Re: PUBLIC HEARING/ SITE PLAN and SUBDIVISION REVIEW: 7-9 Fern Street (PID 239-113 and 239-112): Application by Dirigo Architectural Engineering, LLC on behalf of Jim Wu/Wu Lake Street Property LLC for the construction of a 5-unit condominium development with access from the shared driveway to the former Lake Street school. This property is located in the Traditional Neighborhood (T-4.2B) district and will be reviewed under Chapter 60, Article XVI, Division 2 – Site Plan Review and Division 4 – Subdivision.

Date: September 4, 2025

SUBJECT: UPDATED SUBMISSION DOCUMENTS
Planning Board Project Submission for Subdivision, Site
Plan Approval, and Compliance with the Form-Based Code
PROJECT: 7&9 Fern Street

SITE GRADING &
UTILITIES PLAN

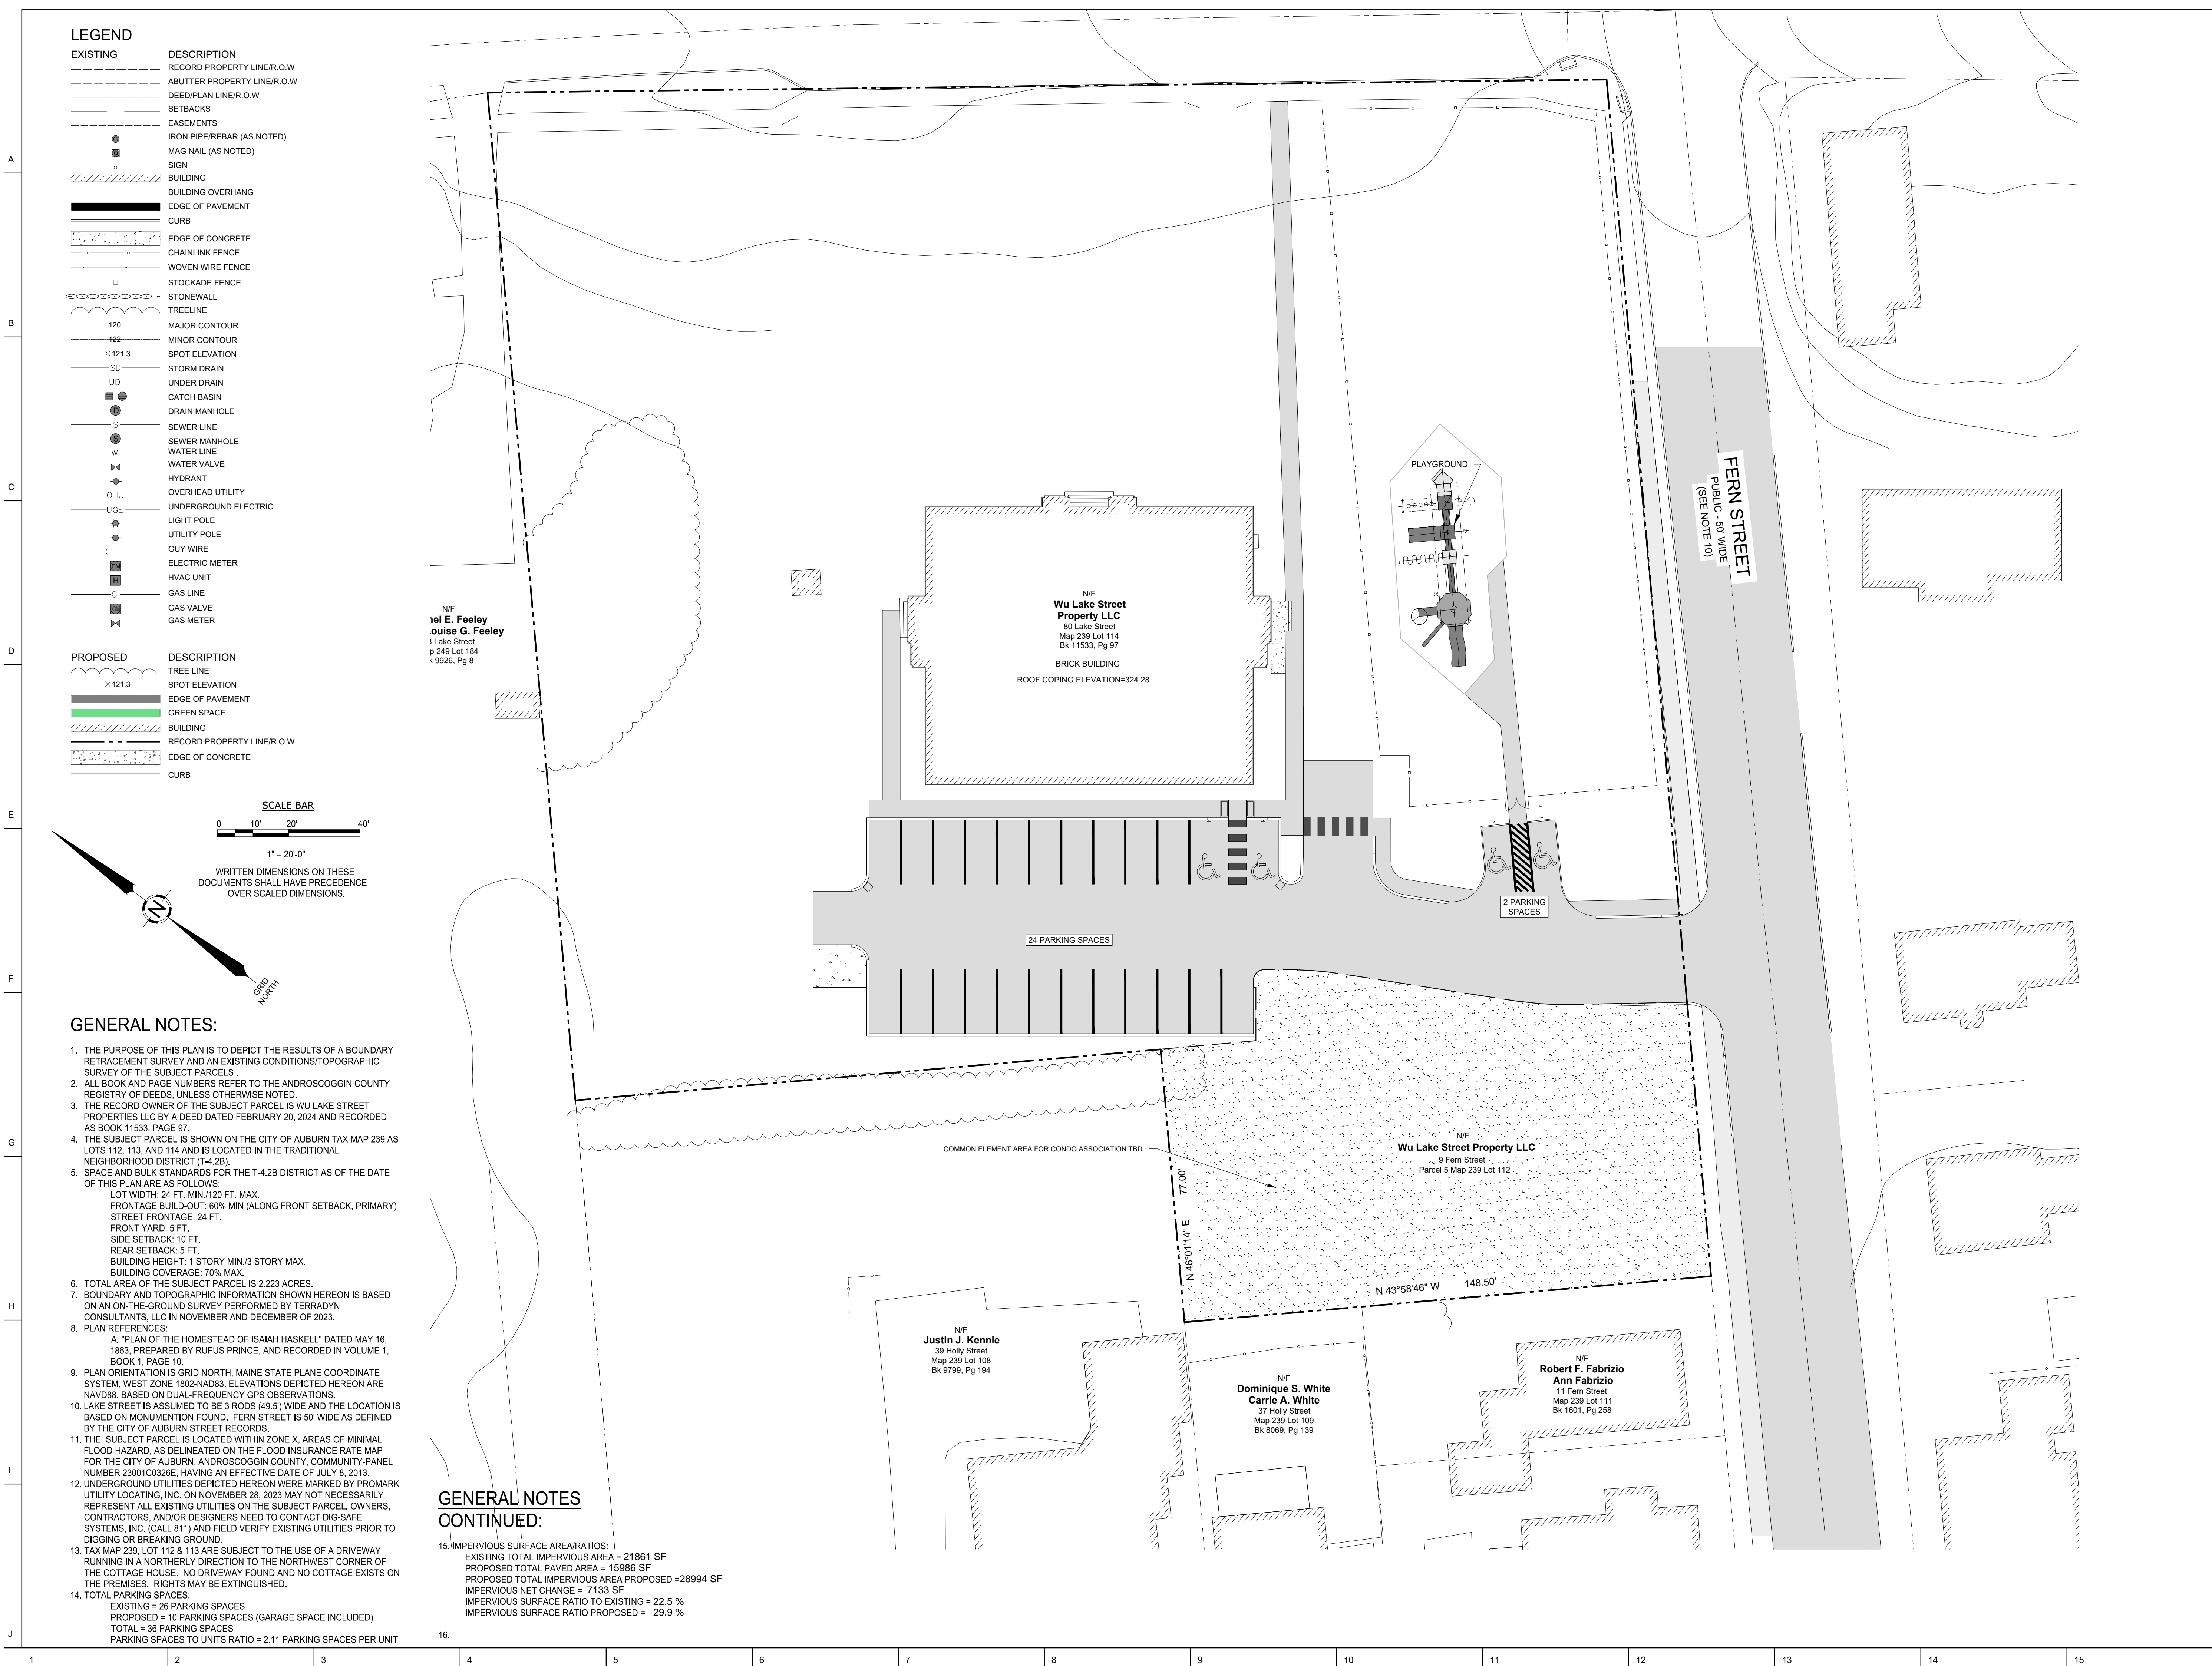
City Engineering has requested a detail in the final plan set for the DMH-1 structure that is supposed to intercept the 18” HDPE. The detail should show backfill materials, bedding, all the standards and include the connection of the existing pipe. A test pit of the location should be called out for exact elevations.

Auburn Water and Sewer has noted that the revised plans show separate lines for water; however, a single sewer service is provided for all five units. This would require the entire building to remain under one owner. If the proposal is for the units to be sold as condominiums, separate water and sewer services for each unit must be shown.

- Staff recommend as a condition of approval that prior to the issuance of any building permits, revised stormwater plans shall be provided to the satisfaction of City Engineering.

- Staff recommend, as a condition of approval, that prior to the issuance of any building permits, revised utility connection plans be provided to the satisfaction of the Auburn Water and Sewer District.
